HISTORIC LANDMARK COMMISSION  
STAFF REPORT

**Mensink House**

Legalization/Appeal PLNHLC2008-227931  
623 East First Avenue in the Avenues Historic District  
September 3, 2008

STAIR DETAIL  
AT CENTER  
OF  
STEPS

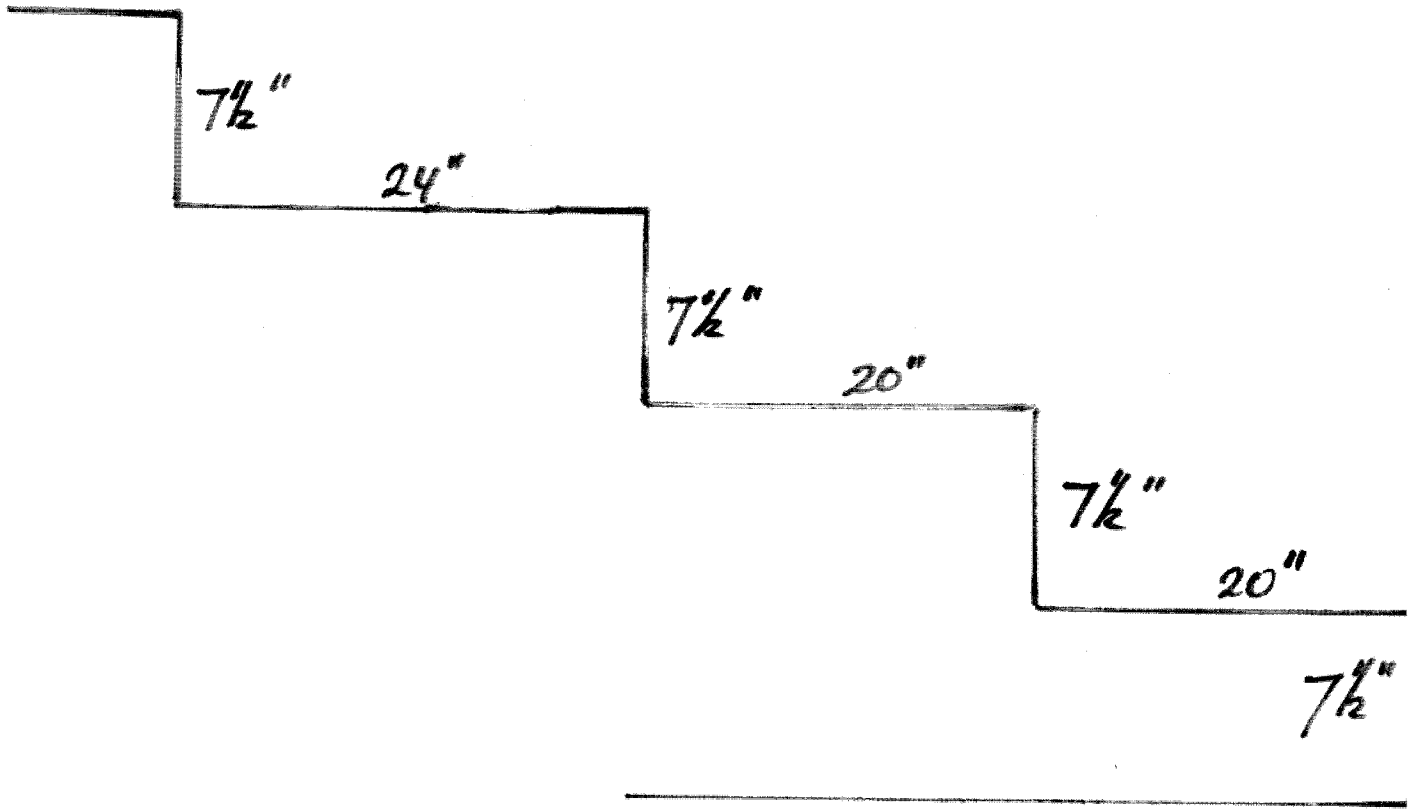
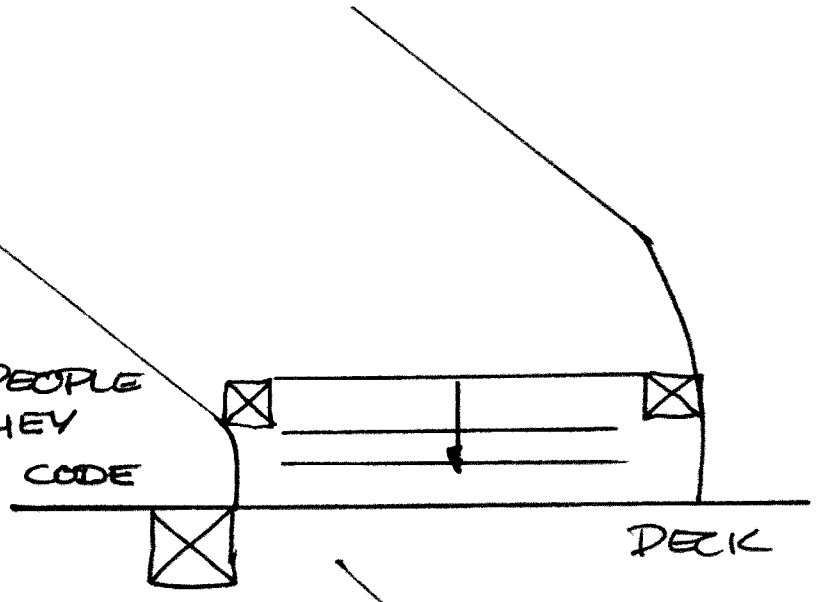
**Analysis:** The applicant proposes a reconfiguration of the historic progression of entry elements to the front of the building. The submitted plans show a brick walkway and curved series of steps leading to the porch. Staff views the historic progression of entry elements a character-defining feature of this site that should be retained.

**Finding:** Alterations that fail to preserve a progression of entry elements, such as installing a curved series of steps which historically ran parallel to a house, negatively affect the character of the historic site as seen from the street. The design of the project is inconsistent with this standard.

**Finding:** The project is inconsistent with this standard because the brick walkway and curved brick covered steps are new elements that are historically incorrect for the building and do not match or resemble the original in form and detail. As such, the project is inconsistent with this standard.

1. That the Commission denies the request to legalize the replacement steps to the front porch, because the design fails to respect the historic progression of entry elements that characterize the property. Should the applicant present a step configuration that respects the original orientation which ran parallel to the porch, staff requests that the Commission directs staff to issue a Certificate of Appropriateness to replace the front steps.

3. That the Historic Landmark Commission denies the request to cover the front steps and walkway with brick because the replacement material is not similar to that used historically on this house. Should the applicant present a replacement material that matches the original material in detailing or is a compatible substitute material, such as concrete, staff requests that the Commission direct staff to issue a Certificate of Appropriateness for the work.
